IMPORTANT SAFETY RECALL 26510

NHTSA RECALL NO. 26V459

International Motors, LLC* has decided that a defect which relates to motor vehicle safety exists in certain 2021 and 2023 thru 2027 International® MV™ Series trucks built 09/21/2020 thru 06/16/2026 and 2026 thru 2027 International® HV™ Series trucks built 07/02/2025 thru 06/16/2026, with the following unique configurations (feature codes):

Figure 1. Overview of Interconnect Cable

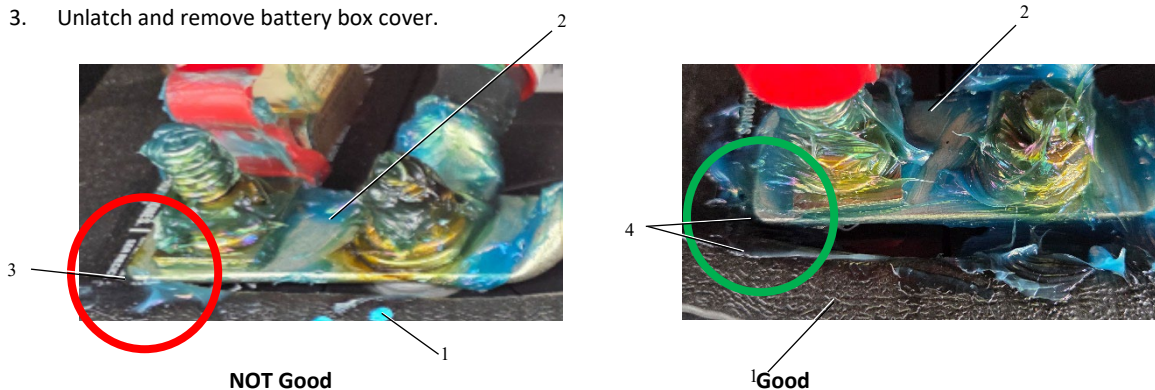
Manufacturing variation can allow for contact between the battery interconnect cable with auxiliary stud and hold-down bracket.

When contact between these components occurs, a short circuit can develop which may generate excessive heat, which can result in a fire, increasing the risk of property damage or personal injury.

To minimize the potential occurrence of this defect in the interim period, inspect for clearance between the positive battery interconnect cable terminals and the battery hold-down. Instructions are included with this letter.

1. Positive battery Interconnect Cable
 2. Battery hold-down (with or without windlace)
 3. Interconnect terminal touching battery hold down – No Clearance
 4. Interconnect terminal not touching battery hold down – Proper Clearance
4. Refer to Figure 1 to verify clearance between battery interconnect terminals and battery hold-down.
 - a. Your vehicle may or may not have rubber windlace on the battery hold-down as indicated in the picture. At this time there is no need to remove or install the rubber windlace.
 - b. It may be necessary to remove a small amount of grease to verify the clearance. It is not necessary to remove all the grease or replace the grease.
